ADDENDUM NO. 2

Invitation for Bids No. 32231R

PVD Canopy Drainage Repairs and ADA Modifications

Rhode Island T. F. Green International Airport

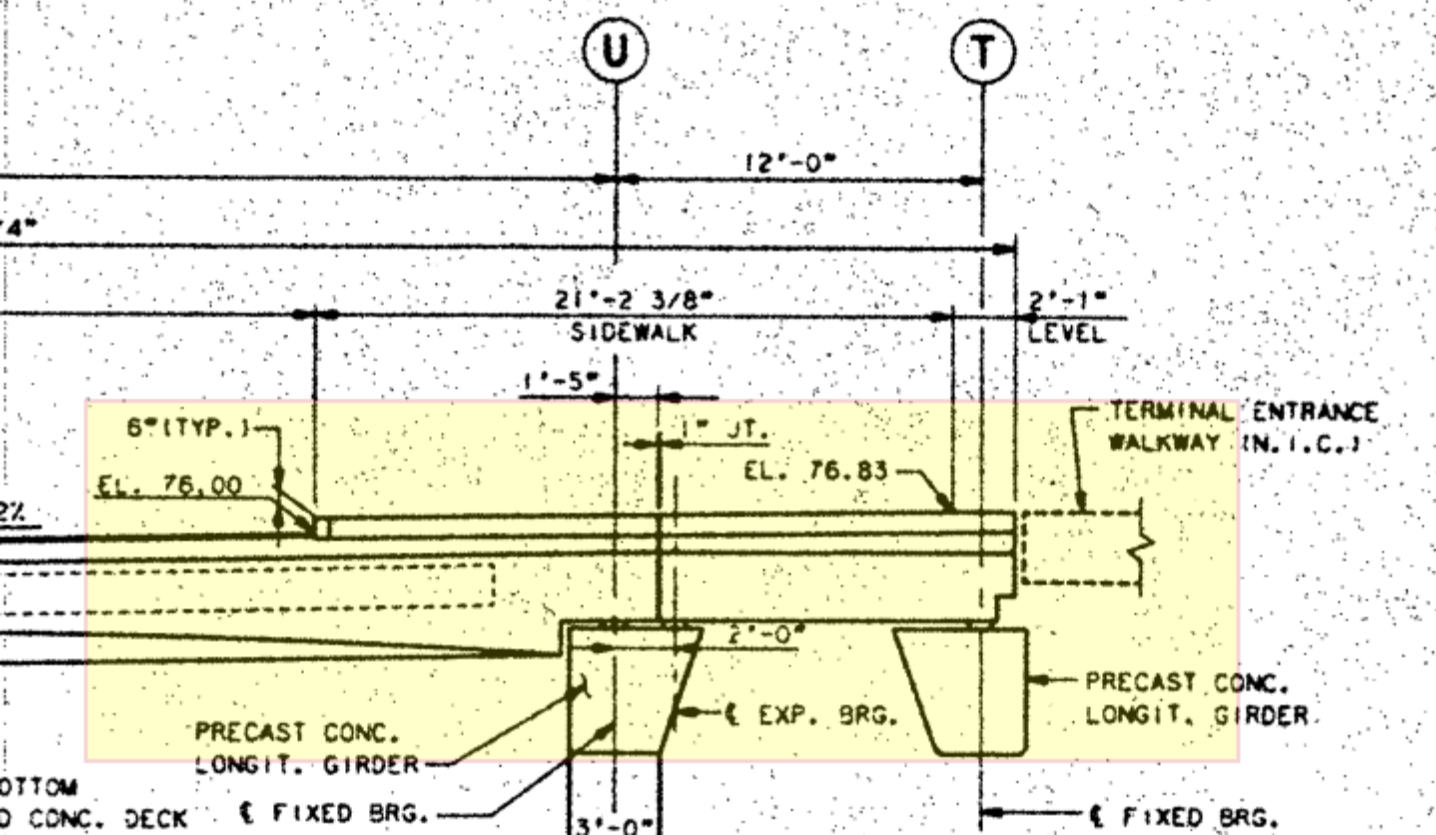
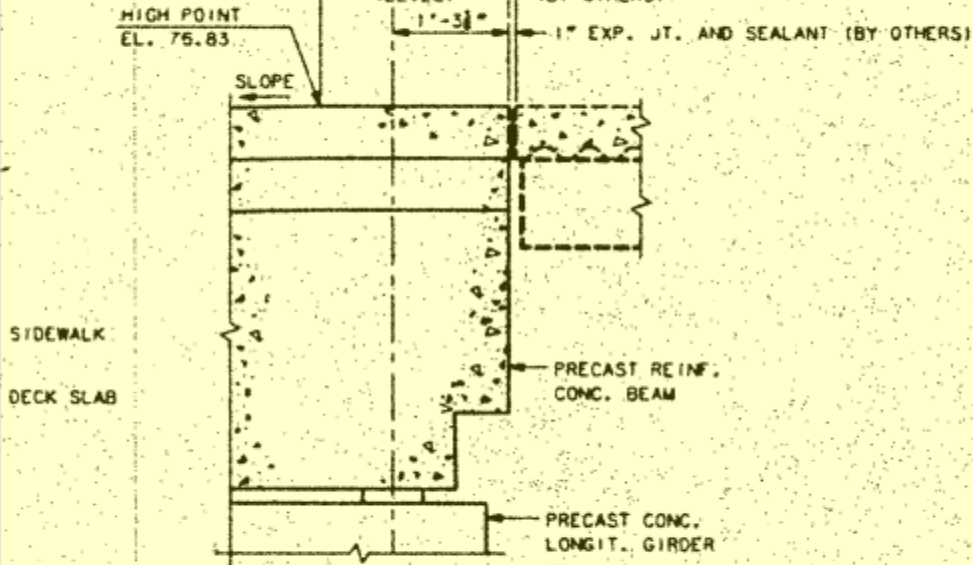
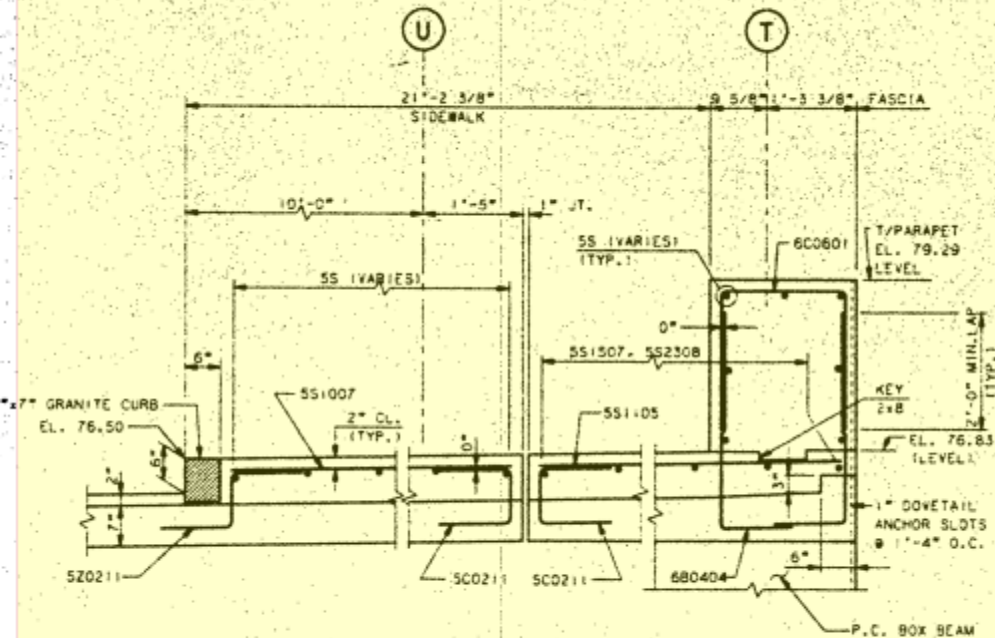
- m. Can you please provide a cut section of the existing elevated deck assembly?
Sections through the existing elevated deck assembly are shown on Drawing A5.11, Detail 3 with information taken from existing drawings. Additional information may be shown in the Landside Improvements Contract 3365X611 drawings by HNTB, dated 3/15/94 and in the T.F. Green Terminal Improvement drawings, dated 9/8/94. Some representative sections are attached to this addendum.
